NMA PLANNING LEGEND

NMA PLANNING ISSUE

Job Title
CHARTER HOUSE AND HORN YARD

Drawing Title
PROPOSED E01 LEVEL 01 GA PLAN

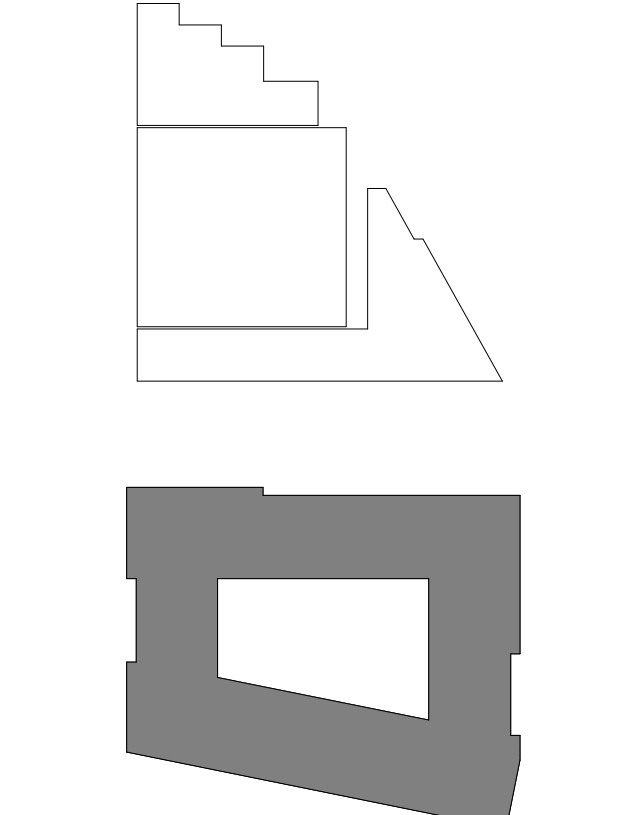
PLANS
INCREASED DISTANCE BETWEEN E01 TO THE OLD
MARKET. E01 MOVED SLIGHTLY NORTH.

COMMON AMENITY AREAS HAVE BEEN REDESIGNED
AND LOBBIES UPDATED.

CORES, COMMON CORRIDORS, AND UPPER LEVEL
DUPLEXES HAVE BEEN ADJUSTED DUE TO FIRE
STRATEGY REQUIREMENTS.

CHANGES TO ROOM LAYOUTS. SUBJECT TO THE
ROOM SIZES MEETING THE RELEVANT LOCAL AND
NATIONAL STANDARDS (INCLUDING THE 20%
AFFORDABLE)

CHANGES TO CAR PARK LAYOUT TO IMPROVE
CIRCULATION. CAR PARKING BAY ALLOCATION
CHANGED TO INCREASE RESIDENTIAL BY 2 AND
REDUCE PUBLIC BAYS BY 2. MOTORCYCLE BAY
PROVISION REDUCED TO 8 (6 PUBLIC AND 2
RESIDENTIAL).
